Access Compliance Report

Public Rights-of-Way

(Curb Ramps)

Intersection ID: 16745	Main Street: MARYLAND_AV	Cross Street: PRINCETON_AV	Location: SW
ADA ID: D7DB5C513A08	Ramp Type: PerpDiag	Initial Pass/Fail: Fail	Overall Compliance: No
Severity Score: 33.75			
Codes/Mitigation Info/Possible Solution		Field Measurements/Component Compliance

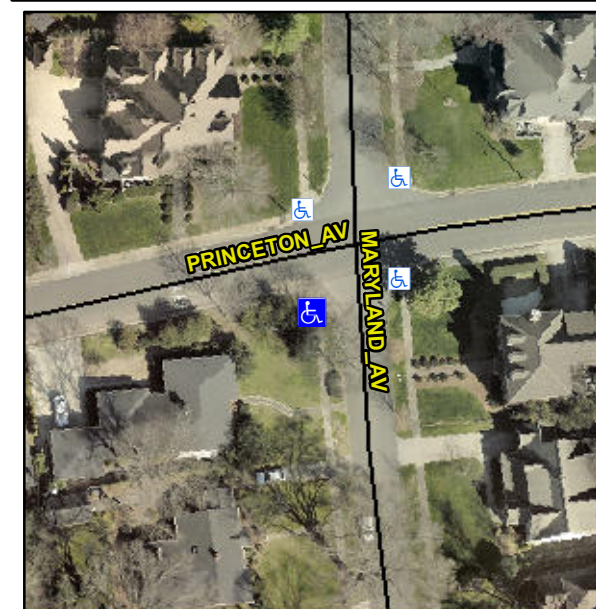
Not Found, R304.5.1, R304.5.3

Compliance	Description	Data	Compliance	Description	Data
N/A	Ramp Length (in)	63.0	Yes	Ramp Slope (%)	5.6
No	Ramp Width (in)	44.0	No	Ramp XSlope (%)	8.6
N/A	Flare Type LT	N/A	N/A	Flare Type RT	N/A
N/A	Flare Slope LT (%)	N/A	N/A	Flare Slope RT (%)	N/A
N/A	Flare Traversable LT?	N/A	N/A	Flare Traversable RT?	N/A
N/A	Landing Length (in)	N/A	N/A	DWS Provided?	N/A
N/A	Landing Width (in)	N/A	N/A	DWS Contrast?	N/A
N/A	Landing Slope (%)	N/A	N/A	DWS Length (in)	N/A
N/A	Landing X Slope (%)	N/A	N/A	DWS Full Width?	N/A
N/A	Landing Curb? (Y/N)	N/A	N/A	DWS Offset (in)	N/A
N/A	Shared Landing?	N/A			
N/A	Gutter Ponding?	N/A	N/A	Gutter Slope (%)	N/A
N/A	Gutter Lip Ht (in)	N/A	N/A	Gutter X Slope (%)	N/A
N/A	Painted X Walk1?	No	N/A	Painted X Walk2?	No
	X Walk 1 Direction	To E		X Walk 2 Direction	To N
N/A	X Walk 1 Width (in)	N/A	N/A	X Walk 2 Width (in)	N/A
	X Walk 1 Slope (%)	4.9		X Walk 2 Slope (%)	8.9
	X Walk 1 X Slope (%)	5.1		X Walk 2 X Slope (%)	2.1

Remove & Replace Curb Ramp With Two New Directional Ramps or Equivalent.
